Process Sheet

Customer : CU-DAR001 Dart Helicopters Services	Drawing Name : HELI UTILITY BASKET LH/RH 350/355
Job Number : 30354	
Estimate Number : 10208	
P.O. Number : N/A	Part Number : D350607043
This Issue : 1/22/2007 S.O. No. : N/A	Drawing Number : D350-607 REV F P7-9
Prsht Rev. : NC	Project Number : N/A
First Issue : N/A Type : LARGE FAB ASSY	Drawing Revision : F
Previous Run : 30118	Material : N/A
Written By : 	Due Date : 2/10/2007 Qty: 1 Um: Each
Checked & Approved By :  07.01.22	
Comment : Est Rev: E as Per DSI9318 06-01-24 JLM

DART SERVICE INSTRUCTION

TO AMEND INSTALLATION INSTRUCTIONS D350-607 REV. F

DESIGN <i>CP</i>	DRAWN BY <i>CP</i>	DART AEROSPACE LTD HAWKESBURY, ONTARIO, CANADA	
CHECKED <i>[Signature]</i>	APPROVED <i>[Signature]</i>	DRAWING NO. DSI 9318	REV. A SHEET 1 OF 1
DATE 06.01.06		TITLE WASHER ADDITION	SCALE NTS
A	06.01.06	NEW ISSUE

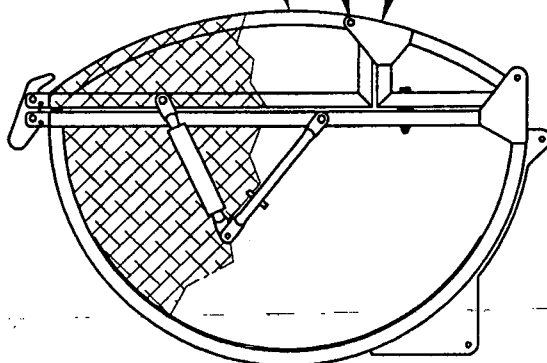
To reduce the possibility of damaging the finish, a **NAS1515H4** washer (2 places) has been added between the hinge plate and basket frame on the **D350-607-043/-047 Heli-Utility-Basket**.

The corrected bolt stackup from Figure 5 of installation instructions D350-607 Rev. F is given below:

AN4-13A BOLT (1)
AN960JD416 WASHER (1)
HINGE PLATE (REF)
NAS1515H4 WASHER (1)
BASKET FRAME (REF)
AN960JD416 WASHER (1)
MS21042L4 NUT (1)
(2 PLACES)
